DS DINETTE ENTERTAINMENT S-O FASCIA

NEWMAR CORP P.O. Box 30, Nappanee, IN. 46550 UNITS: INCHES TITLE BLOCK: 80D	Model:	Sheet	Drawn by:	Checked by:	Revision: PAGE 4 – ADD END BLOCK ON END OF HORIZ FASCIA AT PANTRY CABINET,	By: G. Y.
	NADP 3543	1 OF 5	G. Y.	M. N.	CHANGE QTY TO (2). SHOW END BLOCK DETAIL ON ALL PAGES. (2022 ECO #270)	Date:MN 7/12/21
	Title:	I.D. # 2022\	Date:	Date:	Revision: CHANGED TO 8 X 24 1/4 DOOR ON FACE OF END TABLES ON PAGE 1 &	By: G. Y.
	FASCIA	HE\CAB\FASCIA\NA3543	9/28/20	11/23/20	2. CHNAGED TO NEW FOOT DESIGN PAGES 2,3 &4. (PCR #220375)	Date:MN 2/10/21

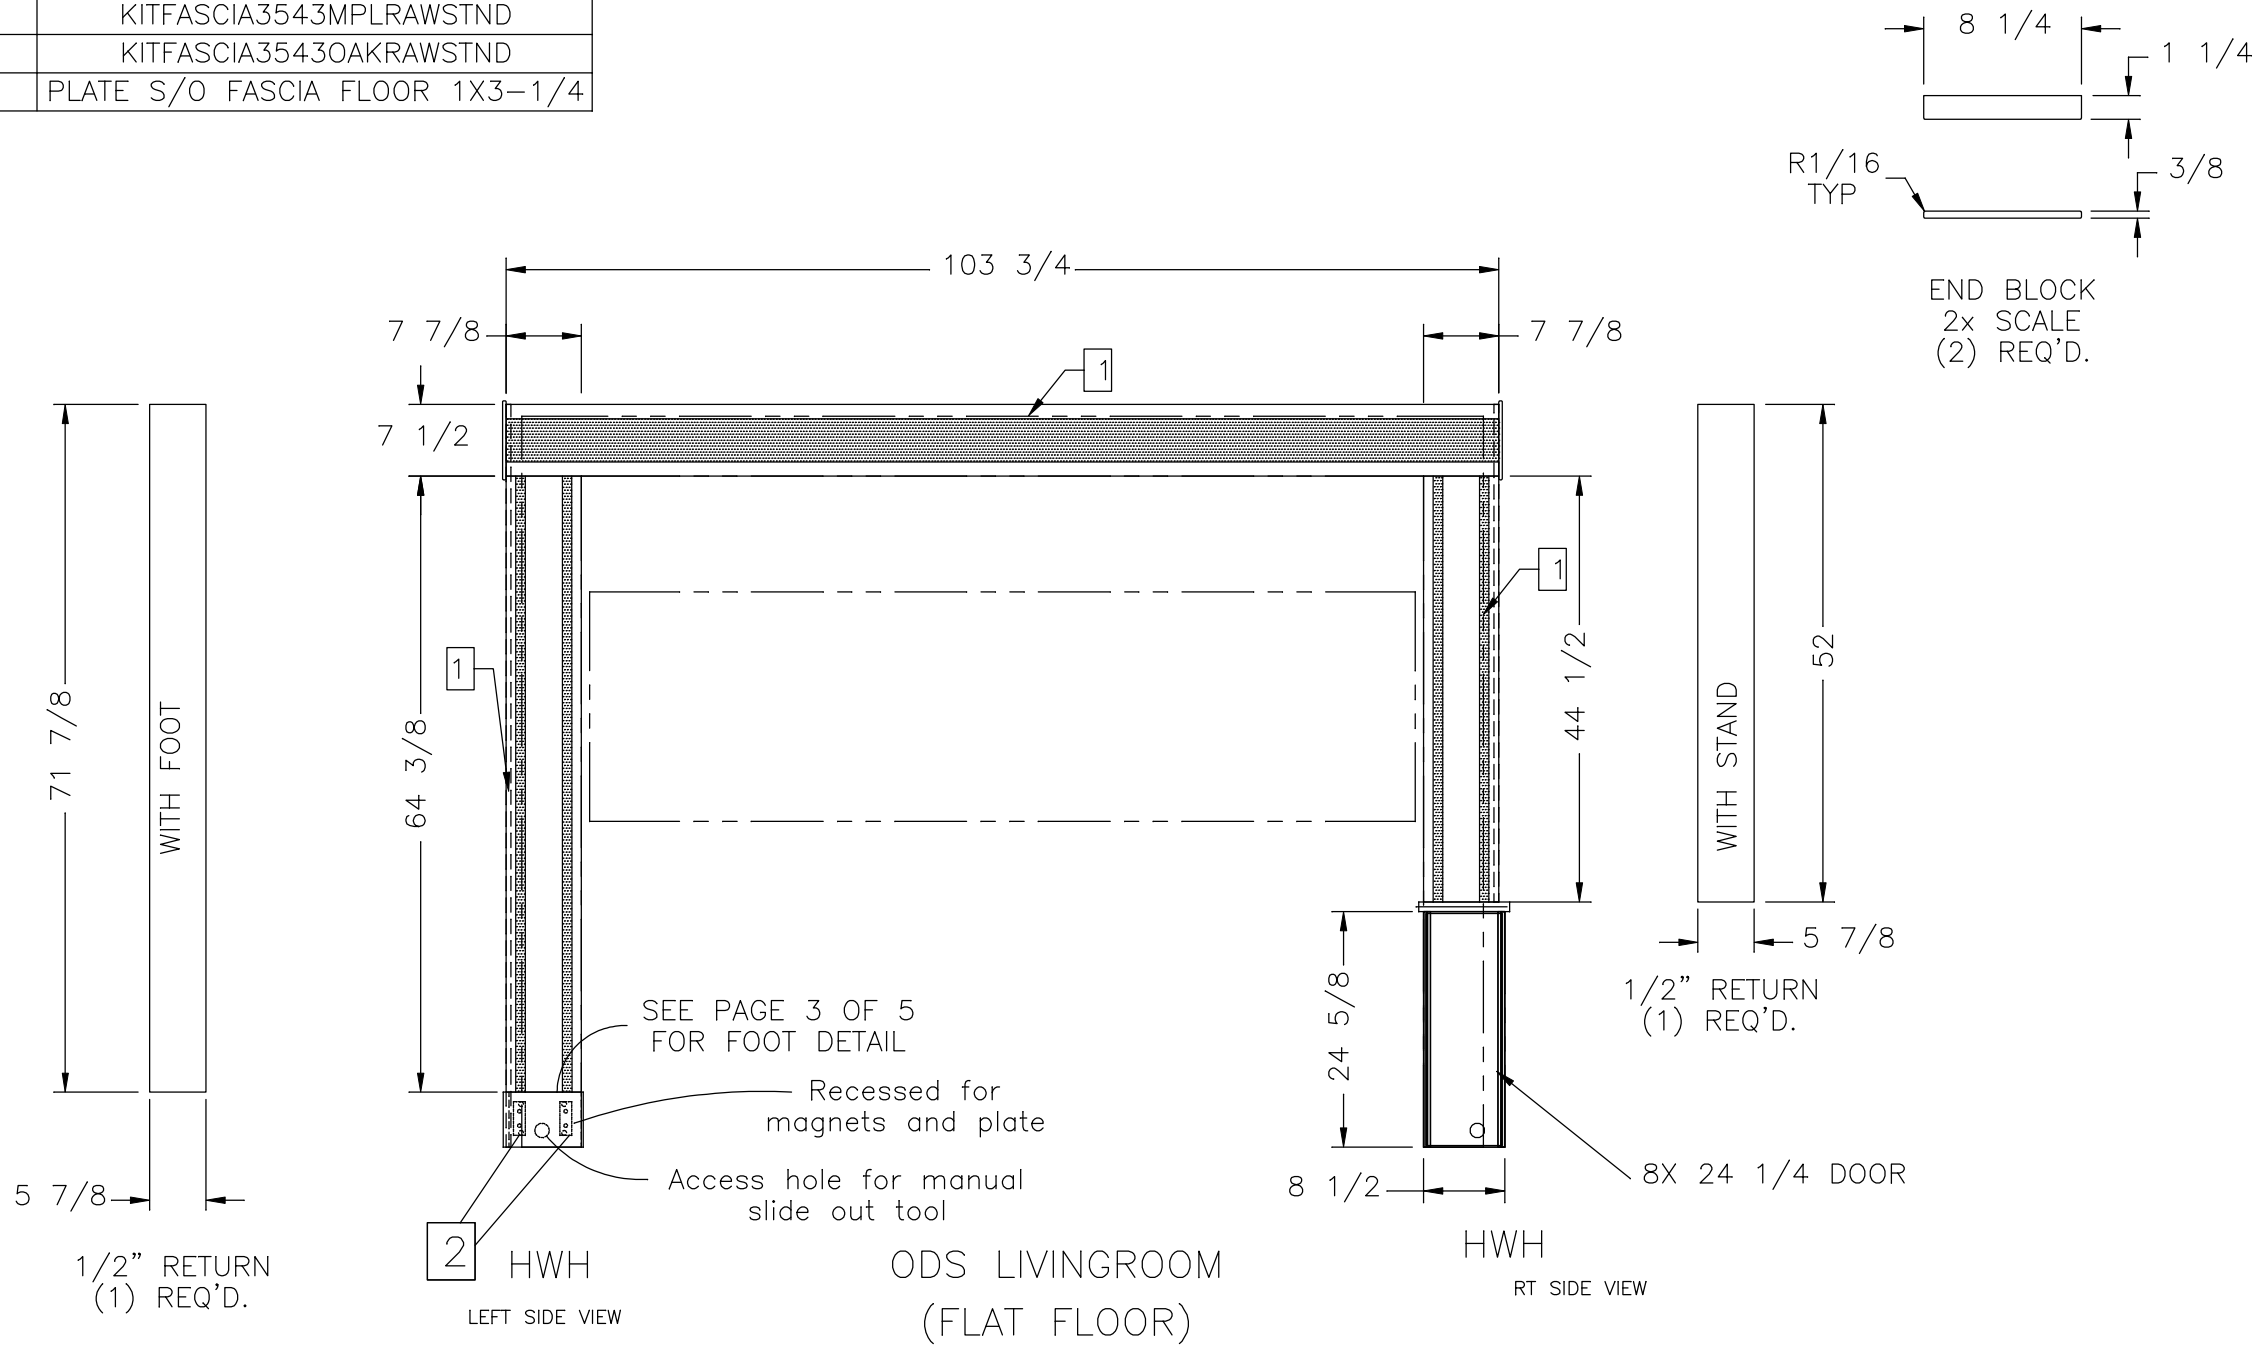
NEWMAR CORP P.O. Box 30, Nappanee, IN. 46550 UNITS: INCHES TITLE BLOCK: 80D	Model:	Sheet	Drawn by:	Checked by:	Revision: PAGE 4 – ADD END BLOCK ON END OF HORIZ FASCIA AT PANTRY CABINET,	By: G. Y.
	NADP 3543	2 OF 5	G. Y.	M. N.	CHANGE QTY TO (2). SHOW END BLOCK DETAIL ON ALL PAGES. (2022 ECO #270)	Date:MN 7/12/21
	Title:	I.D. # 2022\	Date:	Date:	Revision: CHANGE HORIZ FASCIA WIDTH FROM 6-1/2 TO 7-1/2, ADD FASCIA CAP	By: G. Y.
	FASCIA	HE\CAB\FASCIA\NA3543	9/28/20	11/23/20	DETAIL. (2022 ECO #136)	Date:MN 5/28/21

FOOT DETAIL FROM PAGE 2 & 4 OF 5
SCALE X4

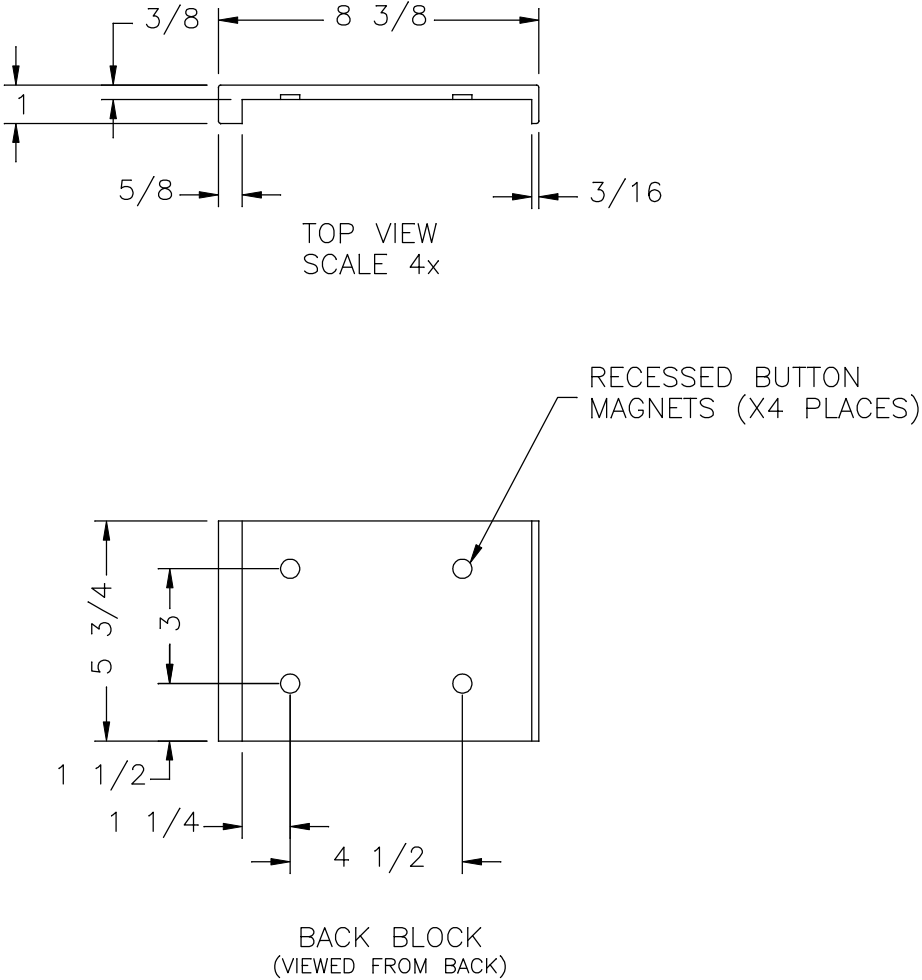
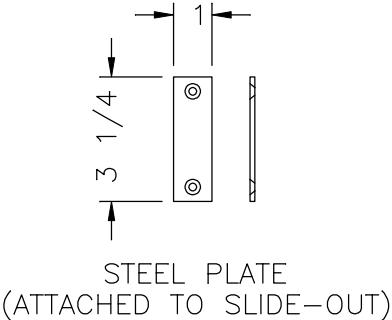
NEWMAR CORP P.O. Box 30, Nappanee, IN. 46550 UNITS: INCHES TITLE BLOCK: 80D	Model:	Sheet	Drawn by:	Checked by:	Revision: CHANGE THE OVERALL DEPTH FROM 1-3/8" TO 1" AND FACE THICKNESS	By: G. Y.
	NADP 3543	3 OF 5	G. Y.	M. N.	FROM 3/4" TO 3/8" (PCR #220693)	Date:MN 4/29/21
	Title:	I.D. # 2022\	Date:	Date:	Revision: CHANGED TO 8 X 24 1/4 DOOR ON FACE OF END TABLES ON PAGE 1 &	By: G. Y.
	FASCIA	HE\CAB\FASCIA\NA3543	9/28/20	11/23/20	2. CHNAGED TO NEW FOOT DESIGN PAGES 2,3 &4. (PCR #220375)	Date:MN 2/10/21

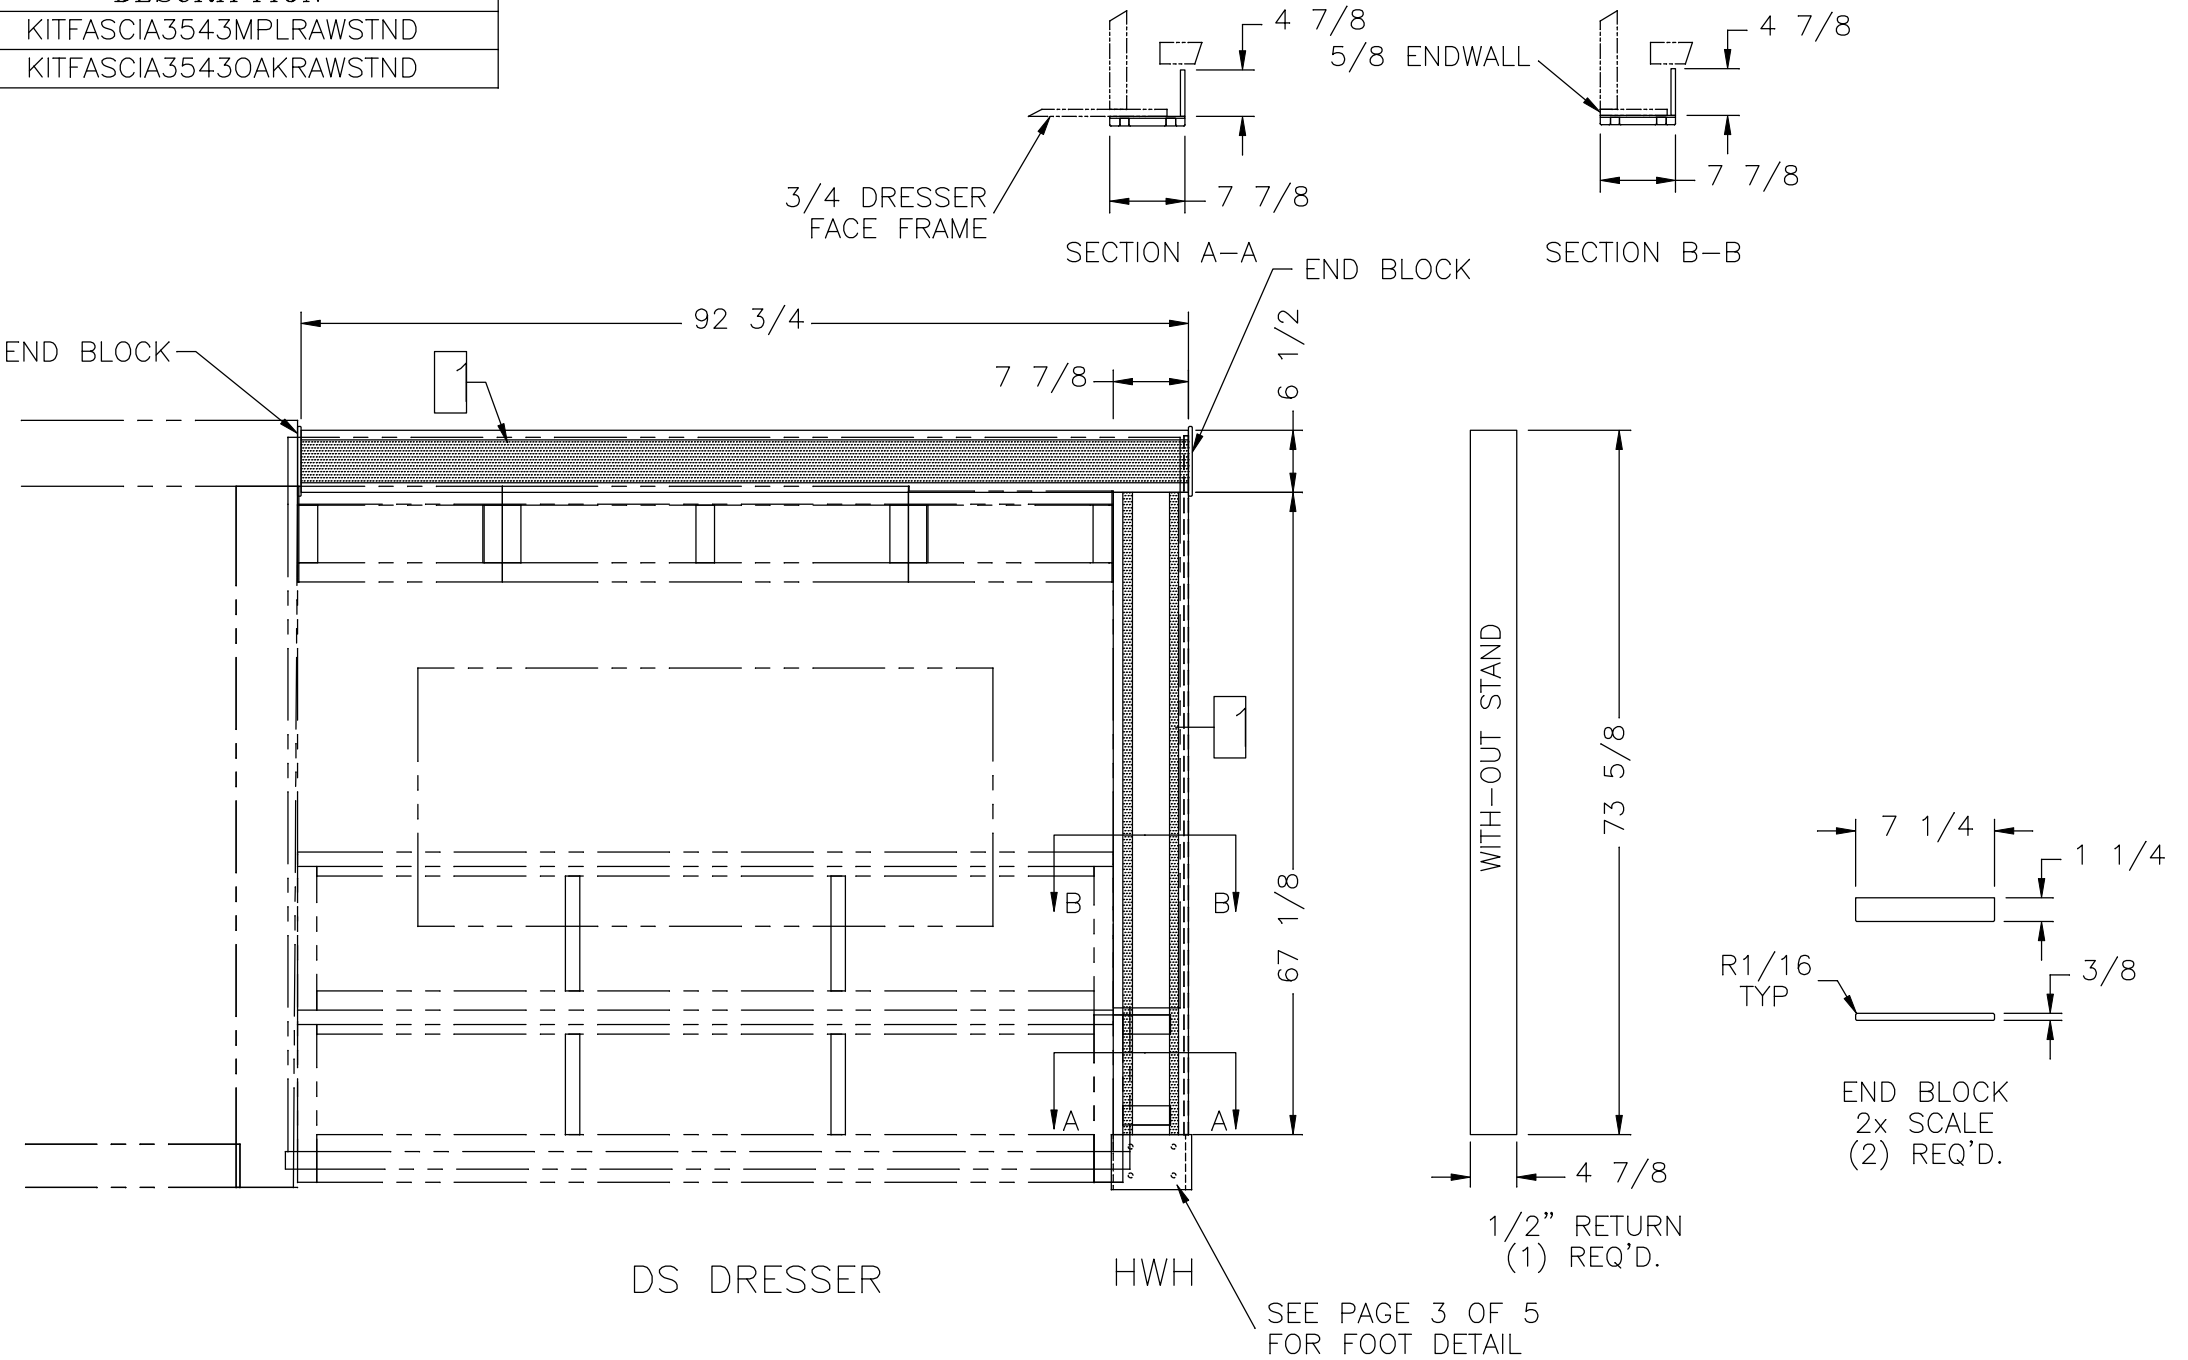
NEWMAR CORP P.O. Box 30, Nappanee, IN. 46550 UNITS: INCHES TITLE BLOCK: 80D	Model:	Sheet	Drawn by:	Checked by:	Revision: PAGE 4 – ADD END BLOCK ON END OF HORIZ FASCIA AT PANTRY CABINET,	By: G. Y.
	NADP 3543	4 OF 5	G. Y.	M. N.	CHANGE QTY TO (2). SHOW END BLOCK DETAIL ON ALL PAGES. (2022 ECO #270)	Date:MN 7/12/21
	Title:	I.D. # 2022\	Date:	Date:	Revision: CHANGED TO 8 X 24 1/4 DOOR ON FACE OF END TABLES ON PAGE 1 &	By: G. Y.
	FASCIA	HE\CAB\FASCIA\NA3543	9/28/20	11/23/20	2. CHNAGED TO NEW FOOT DESIGN PAGES 2,3 &4. (PCR #220375)	Date:MN 2/10/21

ODS BEDROOM
NON—HWH

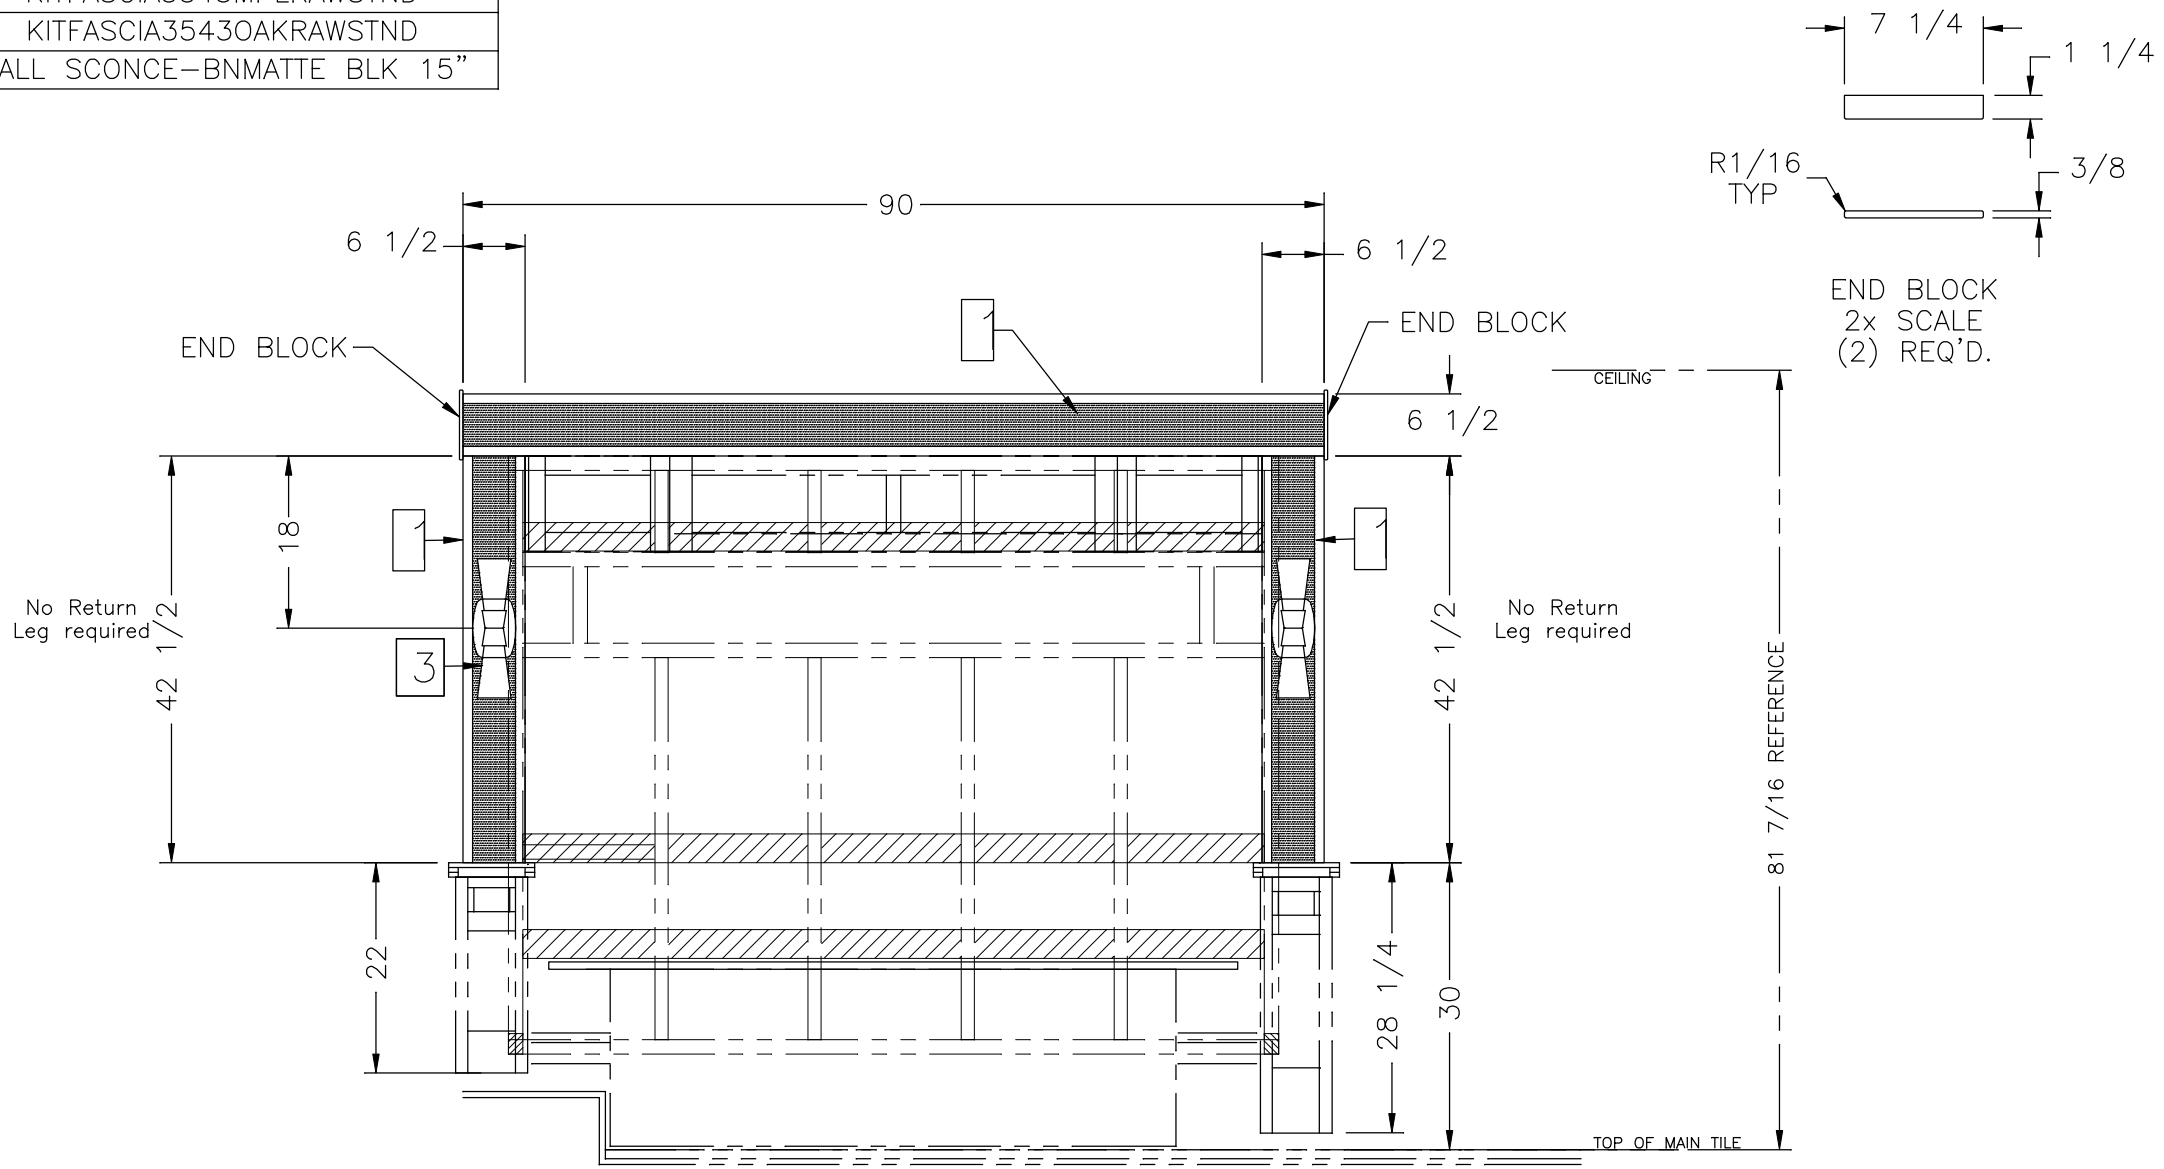
NEWMAR CORP P.O. Box 30, Nappanee, IN. 46550 UNITS: INCHES TITLE BLOCK: 80D	Model:	Sheet	Drawn by:	Checked by:	Revision: PAGE 4 – ADD END BLOCK ON END OF HORIZ FASCIA AT PANTRY CABINET,	By: G. Y.
	NADP 3543	5 OF 5	G. Y.	M. N.	CHANGE QTY TO (2). SHOW END BLOCK DETAIL ON ALL PAGES. (2022 ECO #270)	Date:MN 7/12/21
	Title:	I.D. # 2022\	Date:	Date:	Revision: CHANGE WALL SCONCE LOCATION DIM TO 18” FROM TOP OF THE	By: G. Y.
	FASCIA	HE\CAB\FASCIA\NA3543	9/28/20	11/23/20	VERTICAL FASCIA AND UPDATE SCONCE BLOCK. (2022 ECO #80)	Date:MN 4/27/21
